I am the joint owner and resident of [REDACTED]. I have concerns regarding air quality, noise and light pollution both during works and on completion.

The 'Initial Assessment of Principal Issues' states that particular regard will be given to the cumulative impact of the scheme on [REDACTED] but I would suggest that particular regard is also given to all the other properties in close proximity to the works along Easton Lane and Long Walk. The road will be coming closer to our property [REDACTED]

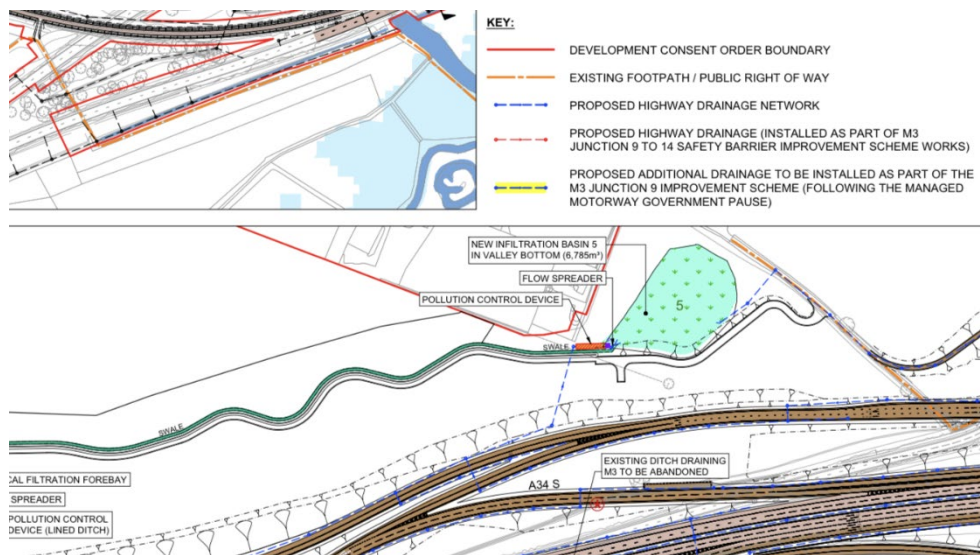
Following my letter to the applicant in November 2022, we received a visit and were told that the basin would only receive run-off from the new bridleway. However, the applicant's Risk Assessment and map (below) clearly shows that it will in fact receive run-off from the road and the bridleway. It is also not clear whether the bridleway will be surfaced or not so the amount of surface run-off cannot be fully understood.

The borehole and the infiltration basin are situated at a low point in the landscape and we are concerned that our drinking water supply will become contaminated. The costs and disruption of a new borehole sited away from the basin, or the installation of mains water and future water costs would be considerable.
